Addendum #: Addendum #5
Issue Date: 04/19/2024

The following additions, clarifications and revisions have been made to the Contract Documents:

EDGAR COUNTY, ILLINOIS EDGAR COUNTY PUBLIC SAFETY CENTER

E601 - STAFF BREAK, EVIDENCE PROCESS
1/4" = 1'-0" (ASA/10)

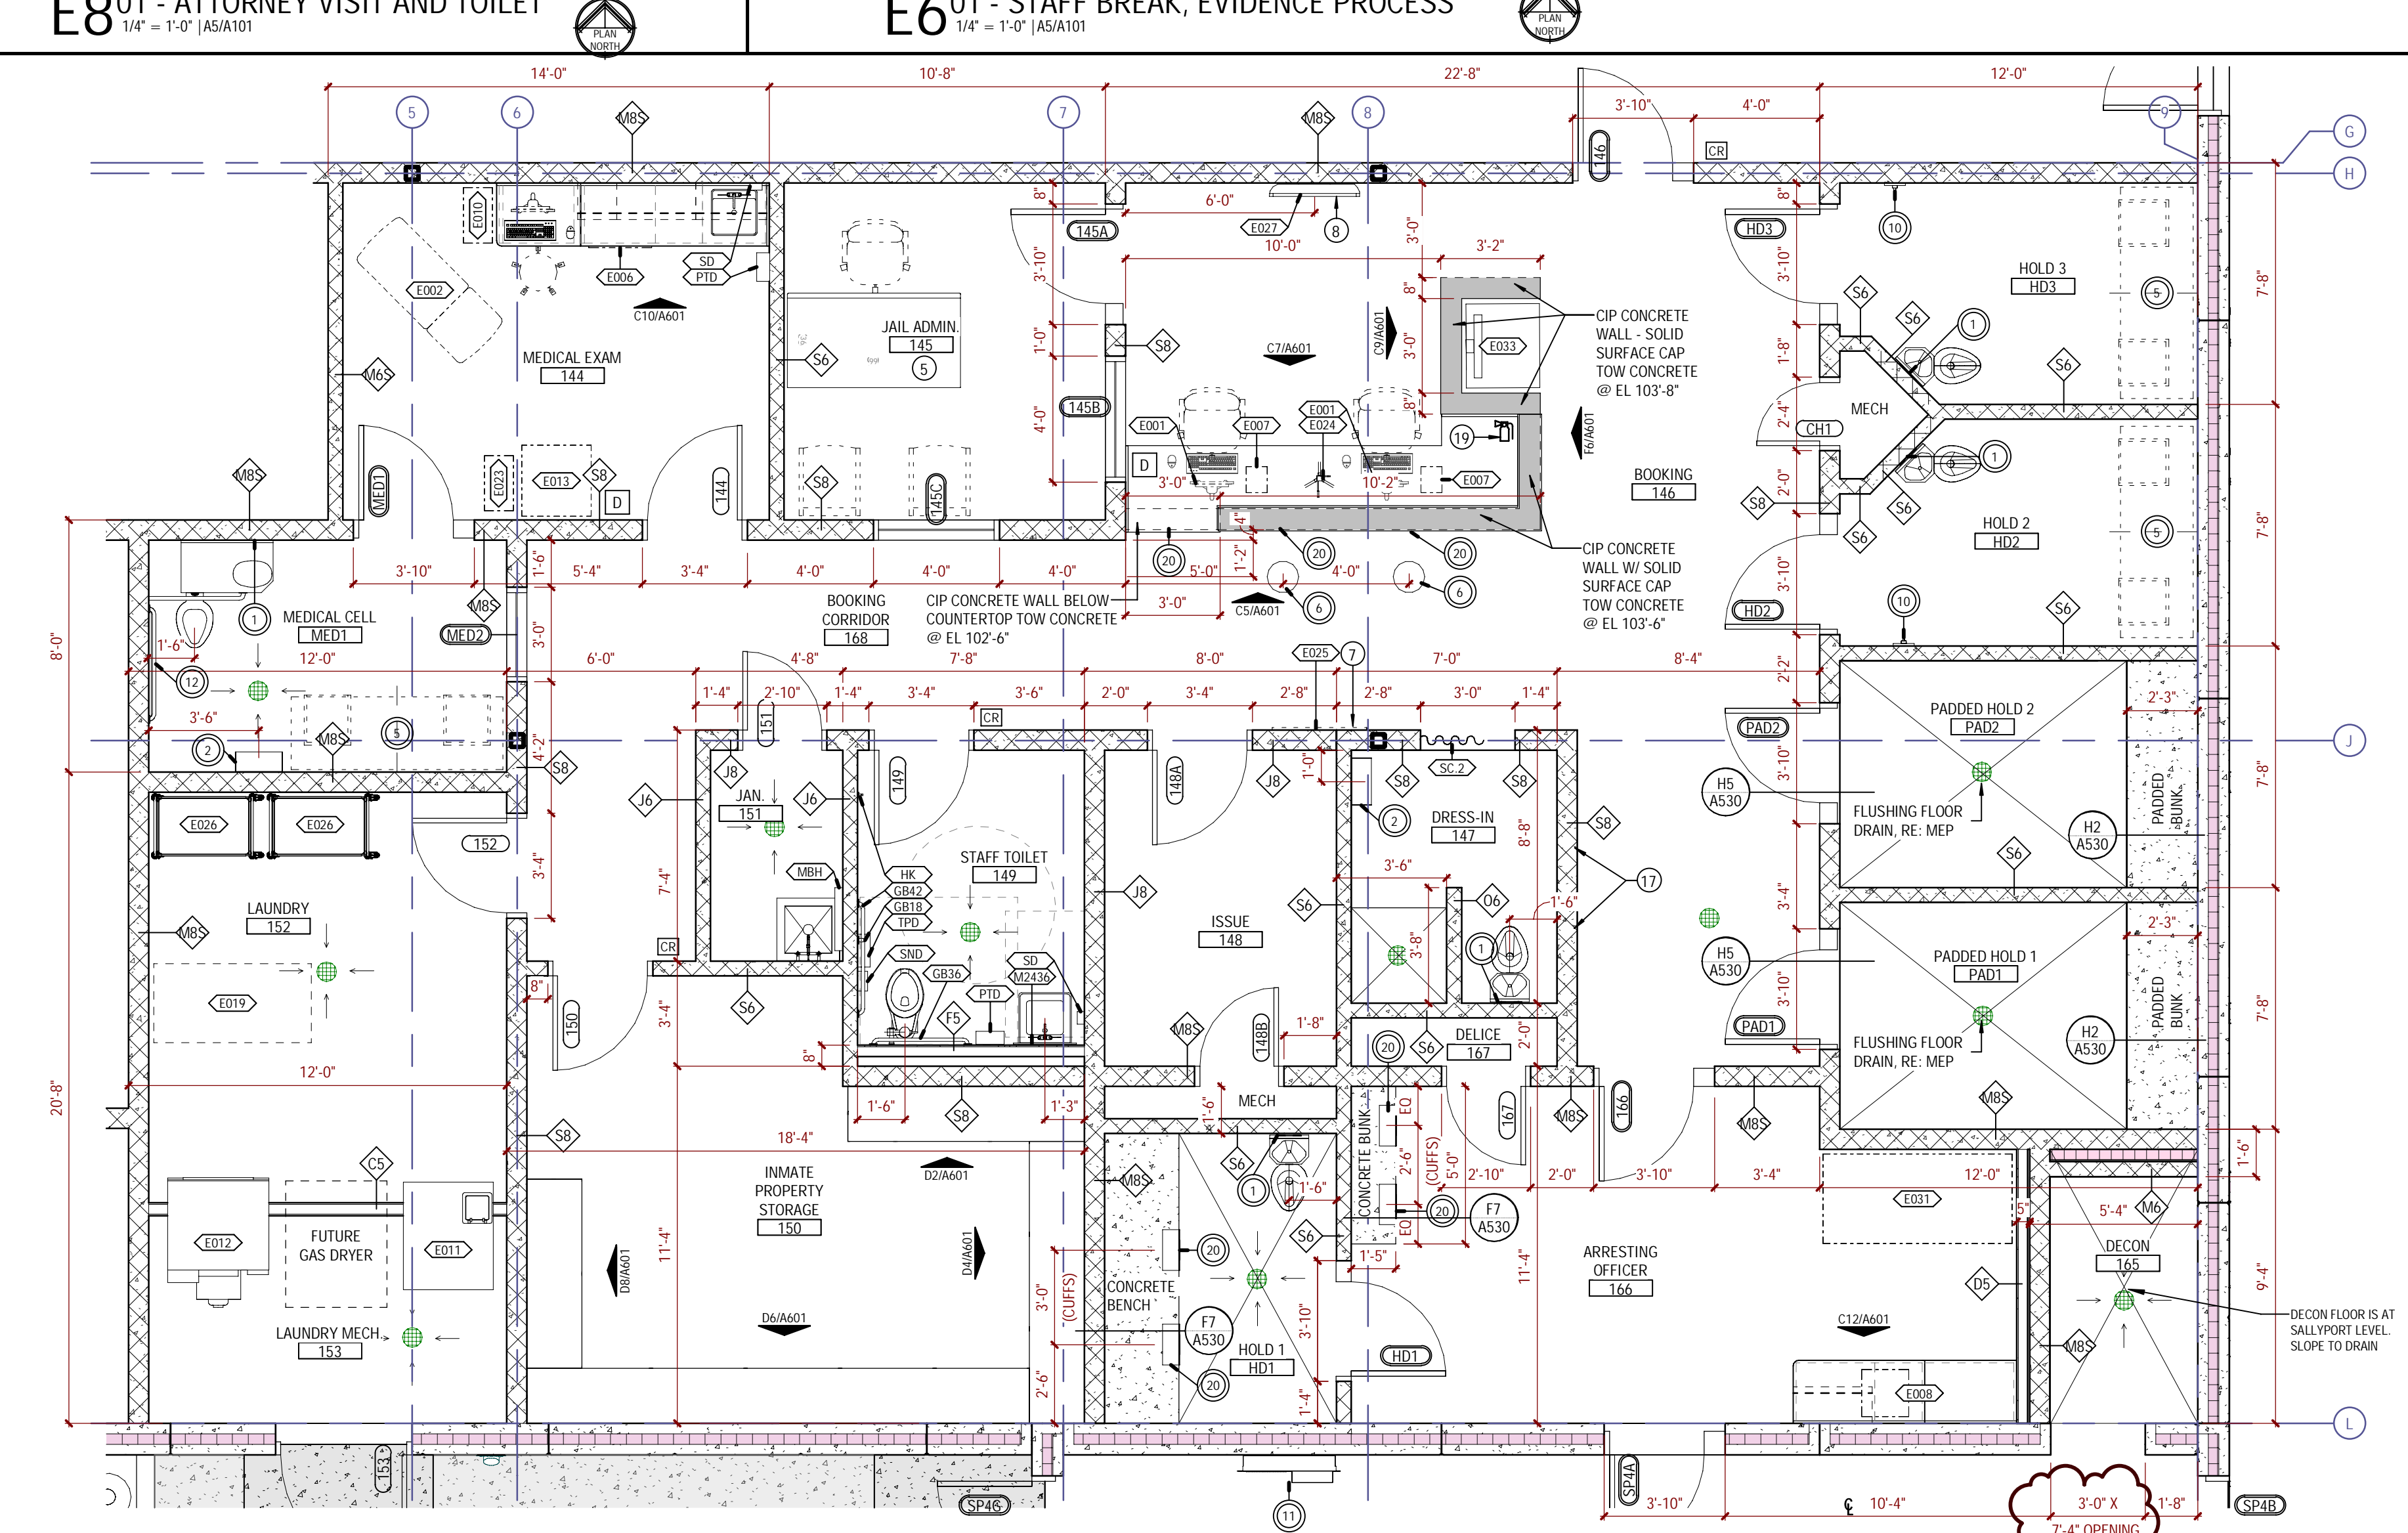
- 1) *Provide items on detention equipment schedule per sheet A130*
 - ~~a.a)~~ *Provide stainless steel drawer and cabinet at package pass per A530/F5 and equipment schedule item E020 on A600*

A:	Amanda Springer (Klingner & Associates, P.C) Responded Fri Apr 19, 2024 at 09:14 am CDT CLARIFY: The floor slab should be flat at the Onyx shower pans and at the ramp (shown by hatch pattern on sheet A130). Beyond these extents, slope floor per structural to the floor drains near toilets. ADD 5
